CCPS RFP#24-15 – NORTH EAST MIDDLE/HIGH SCHOOL REPLACEMENT PROJECT

ADDENDUM #01

NORTH EAST MIDDLE/HIGH SCHOOL REPLACEMENT PROJECT
CCPS RFP#24-15

PARTIAL 01 FLOOR PLAN - AREA F

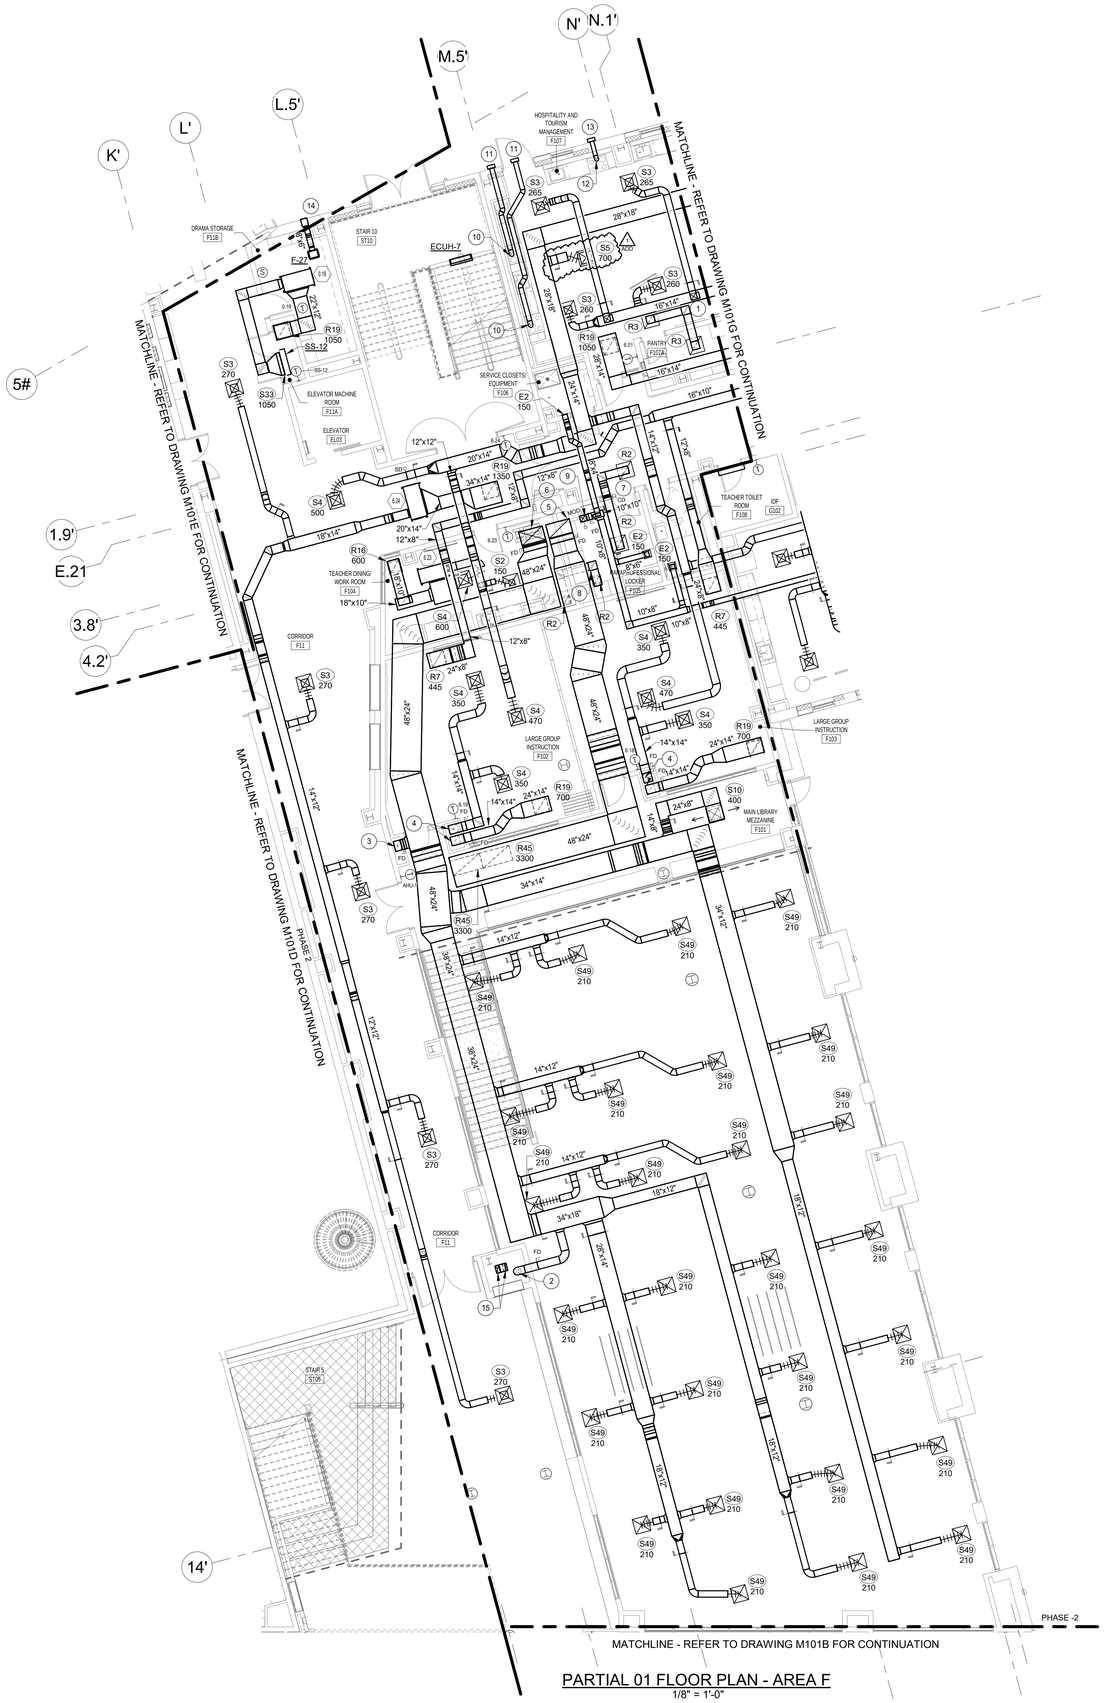
REVISE S4/500 CFM to S5/700 CFM in classroom F107.

PARTIAL 01 FLOOR PLAN - AREA G
1/8" = 1'-0"

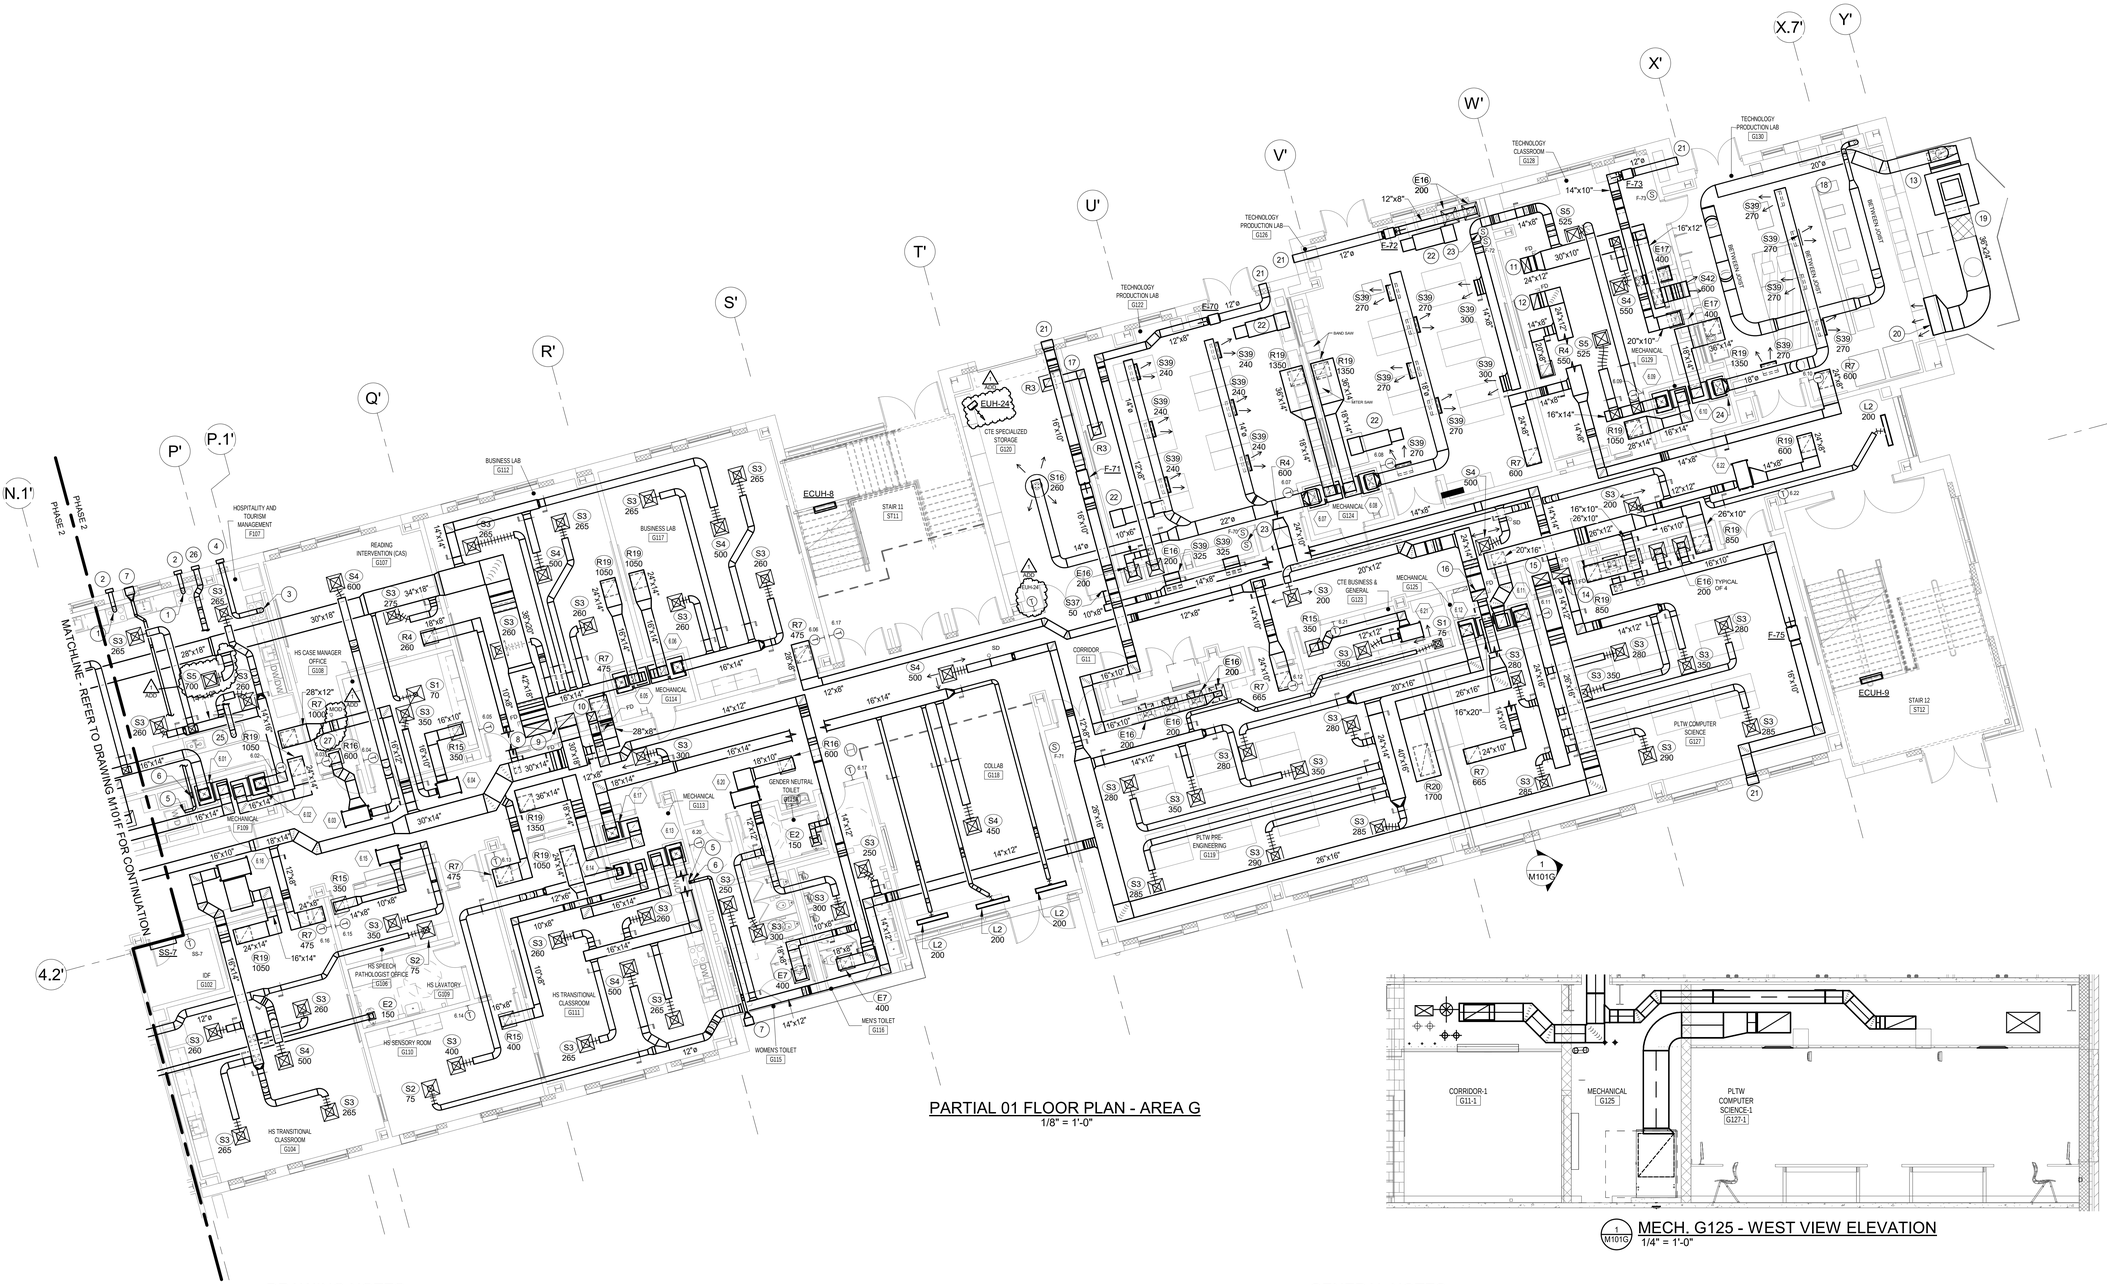
ADD EUH-24 in CTE SPEC. STORAGE G120.

ADD Thermostat in CTE SPEC. STORAGE G120.

REVISE S4/500 CFM to S5/700 CFM in classroom F107.

ADD MOD in 28”X12” return duct to classroom F107 and drawing note bubble 27.

ADD Drawing note 27. Incrementally close return air damper based on quantity of kitchen hood operation. Provide current sensor for each kitchen hood exhaust fan.

LEVEL 01 AREA G PARTIAL FLOOR PLAN - POWER
1/8" = 1'-0"

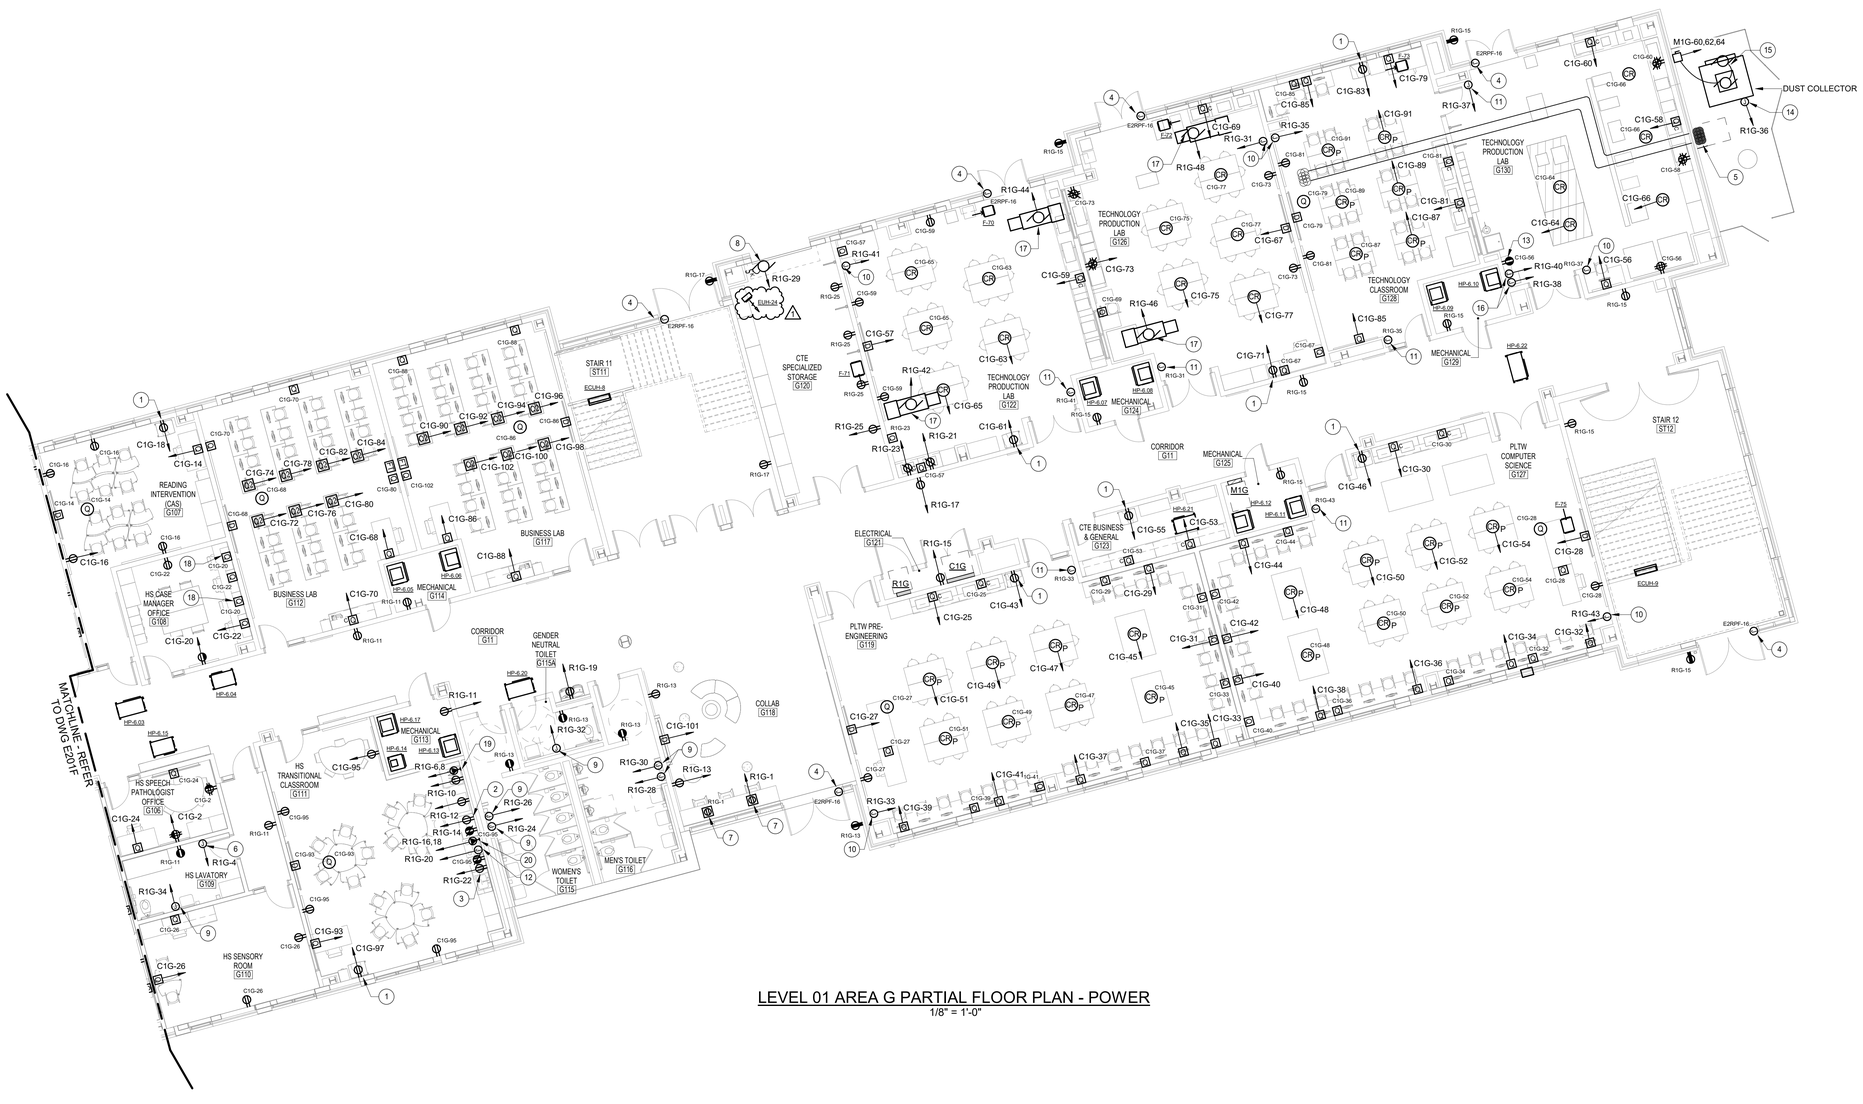
Revise sheet E201G per attached reissued sheet:
ADD EUH-24 to CTE SPEC. SOTRAGE G120.
ITEM NO. E3 SHEET E702 – MECHANICAL EQUIPMENT CONNECTION SCHEDULES

SCHEMATIC POWER RISER DIAGRAM

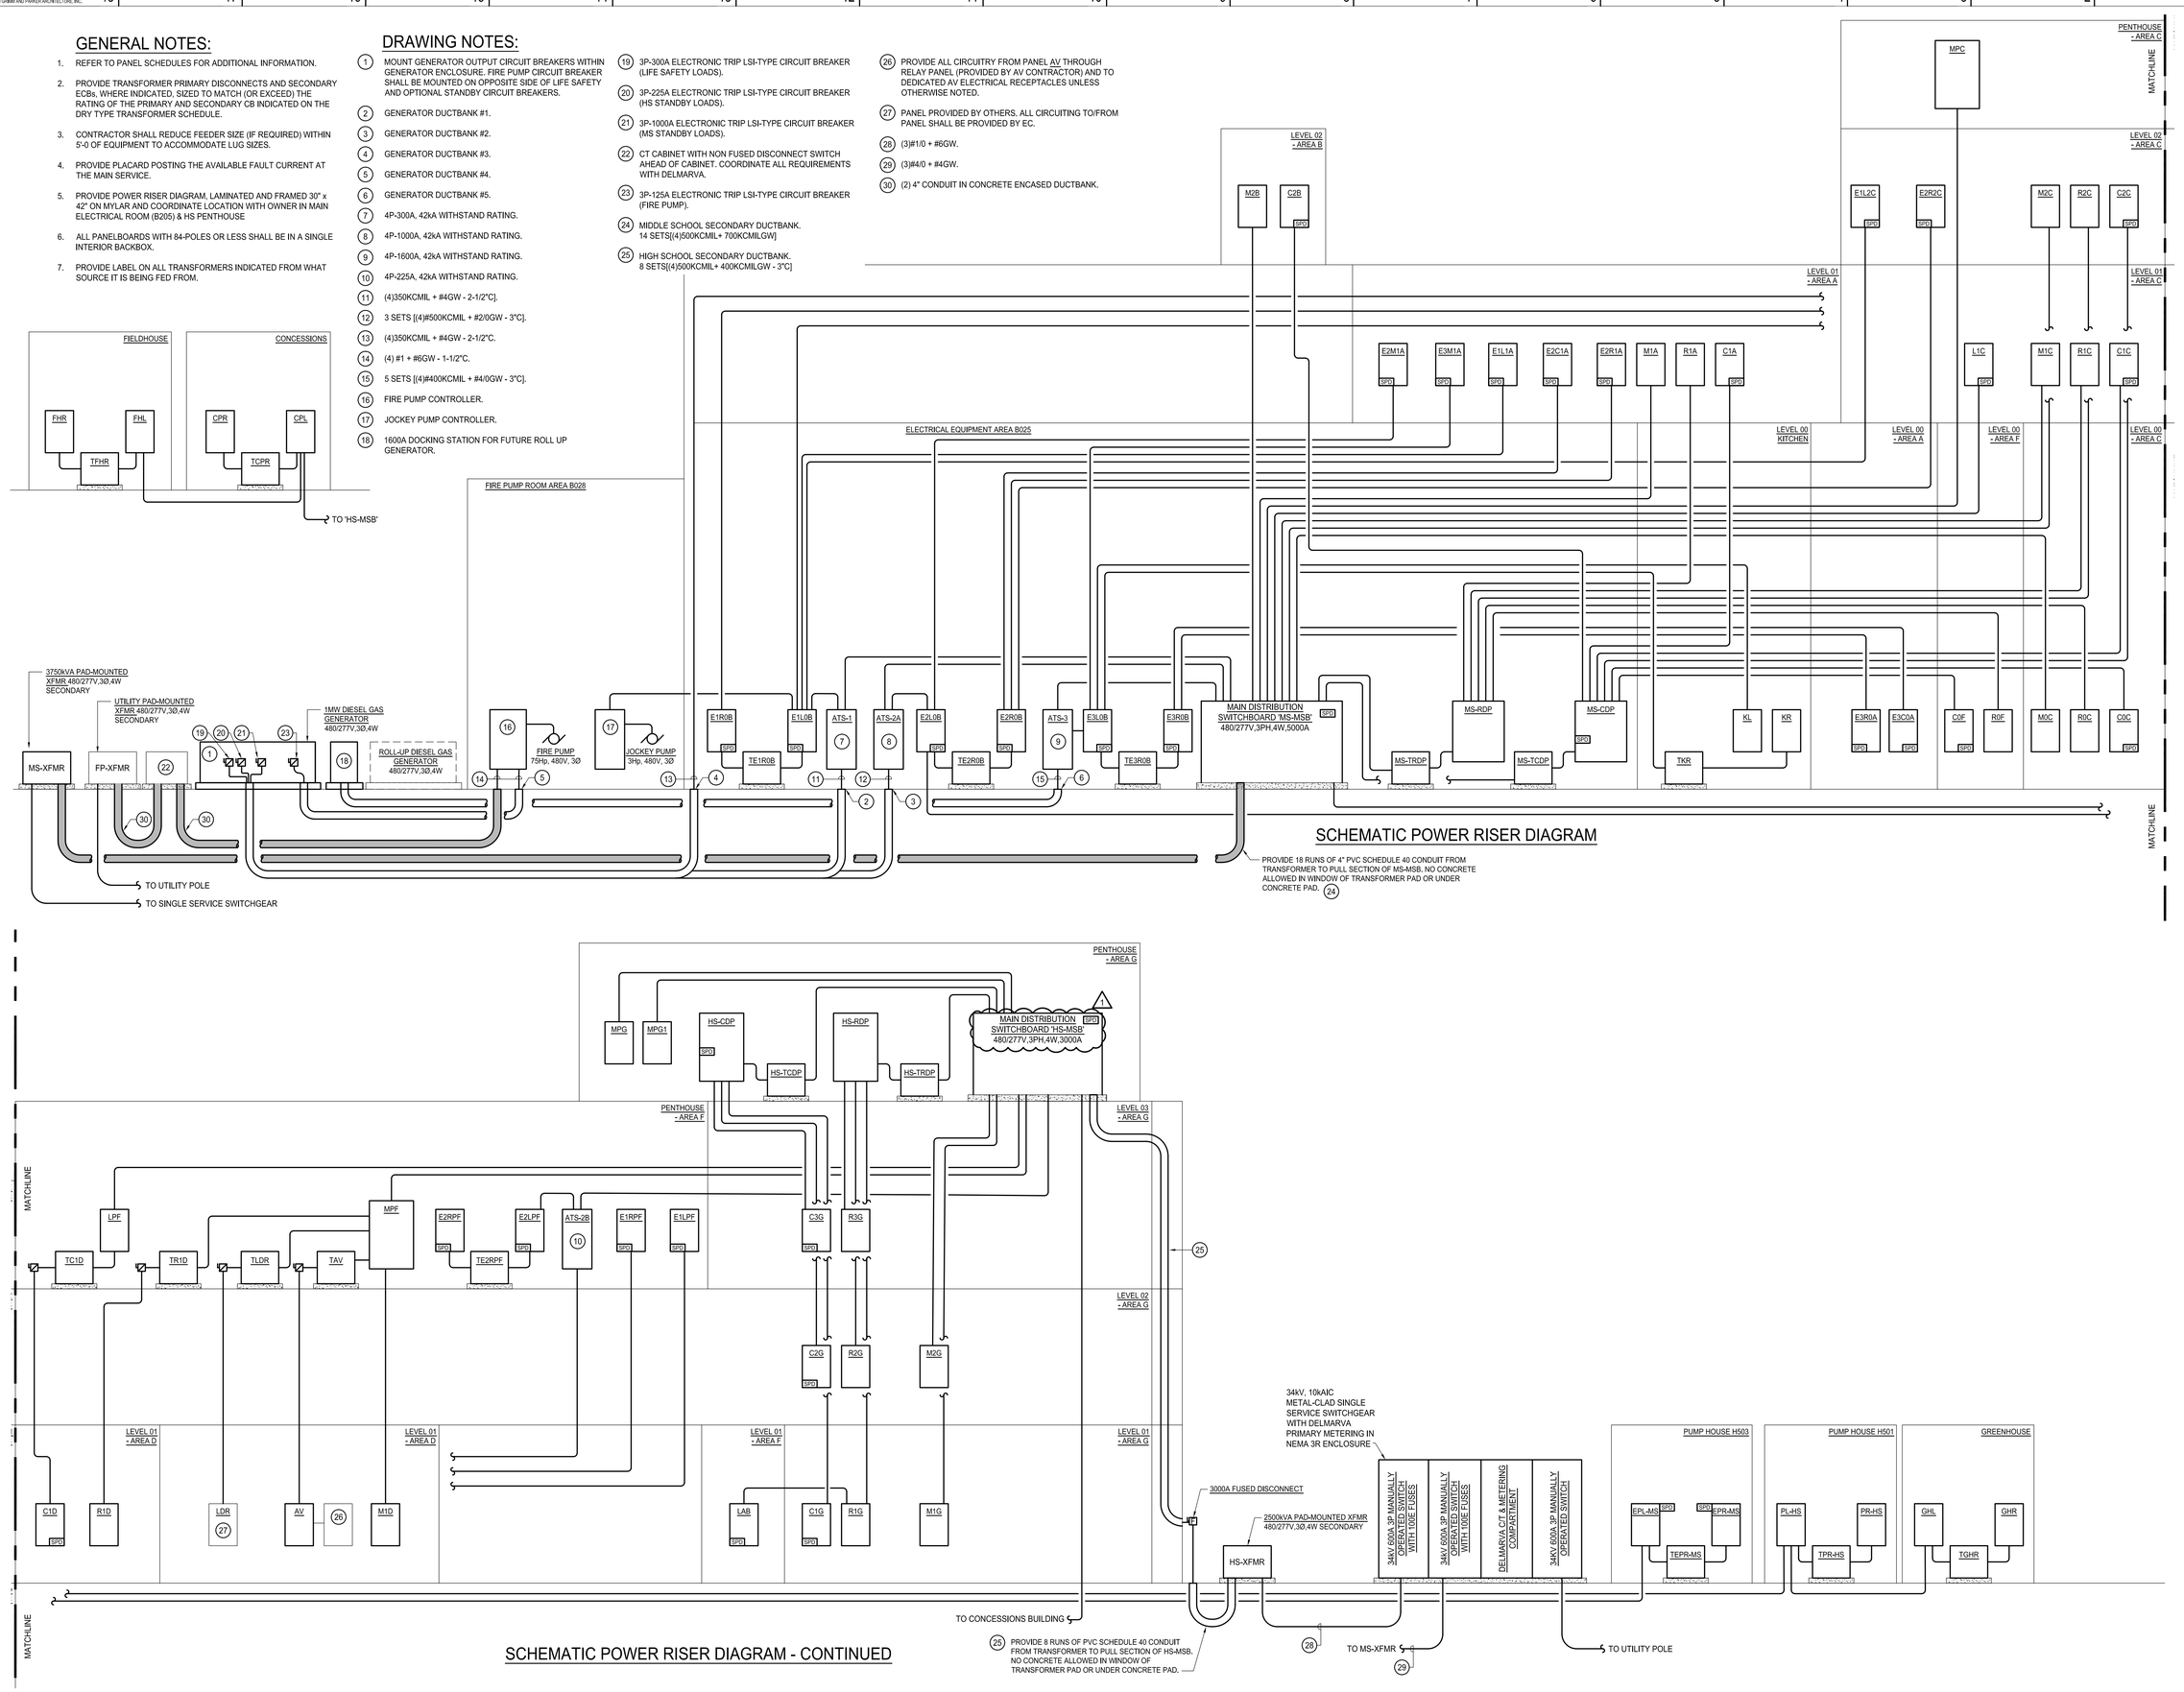
RFI #	Date recvd	Question	Answer
1	2/29/2024	Per drawing E601, HS-MSB is identified as 4000A on the riser diagram, but 3000A in the schedule (drawing E708). Please clarify.	HS-MSB is 3000A. Riser will be updated to reflect
2	3/1/2024	Is Siemens an acceptable alternative fire alarm system manufacturer?	Yes. Manufacturer will be added as acceptable alternative.
3	3/1/2024	Please provide clarification on the floor depression for the walk-in cooler/freezer, Line item 1. Written specs call for 6" deep floor recess, but the Kitchen drawings call for 4" deep recess.	4" depression is correct
4	3/1/2024	Is Automated Logic's Webctrl an acceptable manufacturer substitution for specifications 230900?	No
5	3/1/2024	I was looking into if there were any utility locating services needed on the project in regards to sitework.	Utility location service is required on the project and is covered in several spec sections.

Revise sheet E601 per attached reissued sheet:
REVISE HS-MSB to indicate 3000A in lieu of 4000A.
